PLANNING REPORT

Planning & Zoning Commission

Bridge Park, Block J

24-141CP

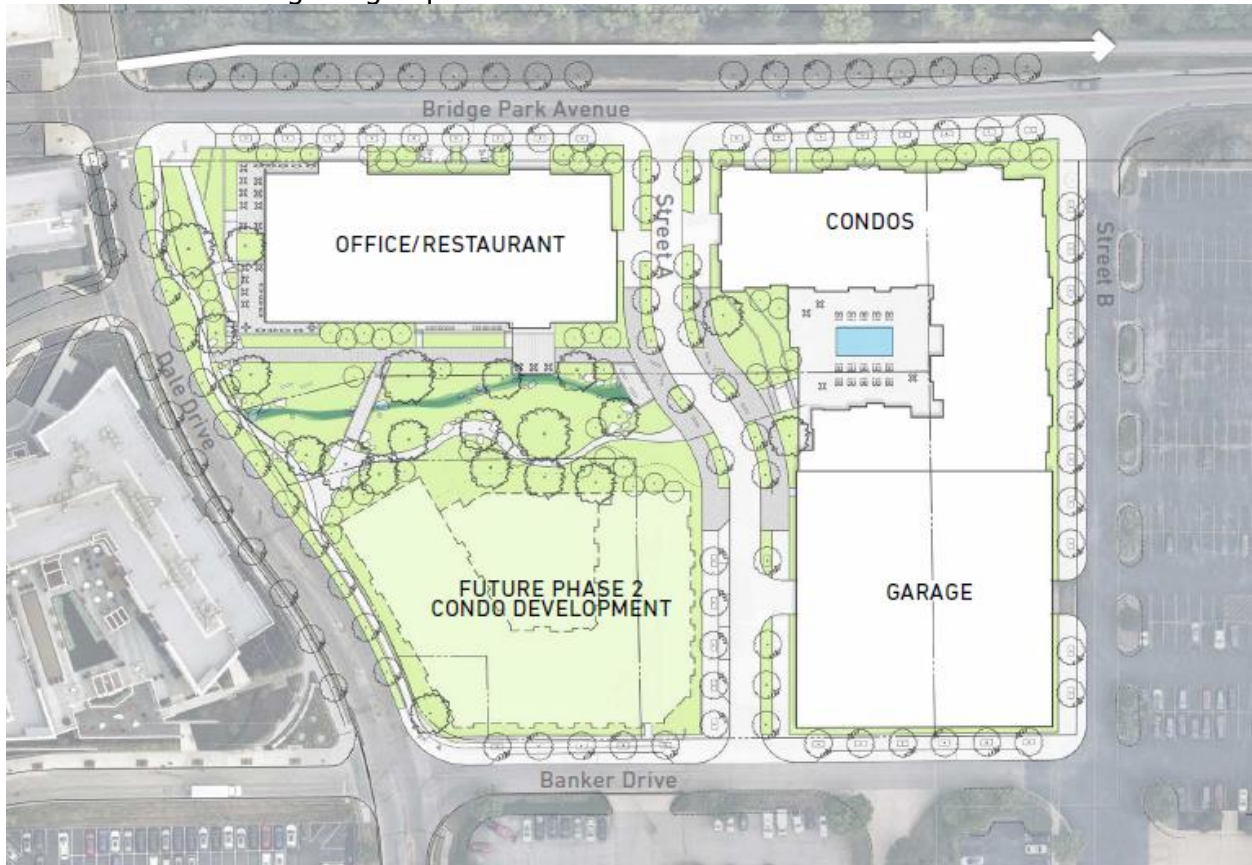
The proposal comprises four buildings: an office/restaurant, two condominium structures, and a parking garage. Phase 1 includes all development except the site’s southwest corner condominium building, which would be part of Phase 2. The footprint of Phase 2 is provided for reference but is not proposed with this application as this portion of the development is still being negotiated. The proposal establishes the general outline for the development, with additional analysis of code requirements and details of materials to be provided with the subsequent applications.

Three buildings are currently proposed with Phase 1 of the development. The office building is proposed in the northwest corner of the site at the intersection of Bridge Park Avenue and Dale Drive; the condominium building in the northeast corner of the site at the intersection of Bridge Park Avenue and Street B (Dave Thomas Boulevard); and a garage building in the southeast corner of the site at the intersection of Banker Drive and Street B. Street A is a proposed new north-south private service street that would split the property in half. Public open space is proposed in the western half of the development, connecting Dale Drive and Street A. Additional open space is provided across Street A between the condo building and the private street.

Buildings within the Bridge Street District are typically required to occupy the corner of a property at the intersection of public streets. However, due to the significant grade change at the Bridge Park Avenue and Dale Drive intersection, the office building is set back ±35 feet from Dale Drive. Permitted open space types are allowed to occupy the corner of the lot instead

of the building. A Waiver could be required with a Preliminary Development Plan for this deviation from building siting requirements.

The development is expected to have frontage on five streets: Dale Drive (Public/Principal Frontage Street), Bridge Park Avenue (Public/Principal Frontage Street), Banker Drive (currently Private/to-be Public), Street A (to-be Private), and Street B (to-be Public). Dale Drive and Bridge Park Avenue are currently not built to Bridge Street streetscape standards but will be updated with the development of this site. Banker Drive is presently a private street owned by Cadillac to the south. The proposal currently shows the portion of the Banker Drive streetscape on the proposed site to be updated to meet the streetscape standards. However, additional discussions between the city and the applicant are necessary to determine the future of the street with the development of this site. Street B (Dave Thomas Boulevard) is also a private access drive expected to provide public access to the proposed garage on the site's east side. Additional discussions between the city, the applicant, and Wendy's are necessary to determine how the street should be approached to accommodate the new development and the needs of Wendy's operations to the east.

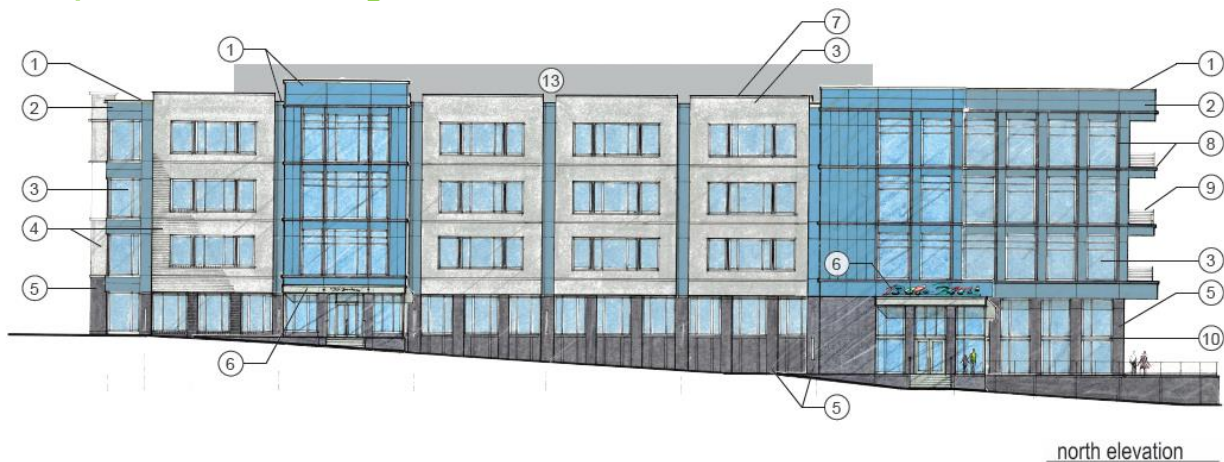
The primary public open space is centrally located between the office building and the Phase 2 condominium building. The intention for the design of this public open space is a greener and more natural environment, including a proposed revitalization of an existing stream bed to assist in the site's stormwater management strategy. It would be supplemented by

benches, decking/boardwalk and additional greenspace with pedestrian facilities throughout the center of the development that would drive pedestrian activity throughout the site. The applicant has not identified the open space type at this time but will be required to provide an analysis of the open space requirements with the Preliminary Development Plan.

Open Space requirements within the Bridge Street District are dictated by the uses in the development. 1-square-foot of open space is required for every 50 square feet of commercial development, and 200 square feet of open space for each dwelling unit. For a mixed-use scenario, the requirements for open spaces are individually calculated. Based on the conceptual square footage of the development, ±1.10 acres of open space are required. This acreage includes the anticipated phase 2 development of the condominium building. The applicant has not indicated the proposed open space for the development. Should the open space be less than the required acreage, the Commission would need to consider whether a waiver would be supported based on the design and quality of the open space.
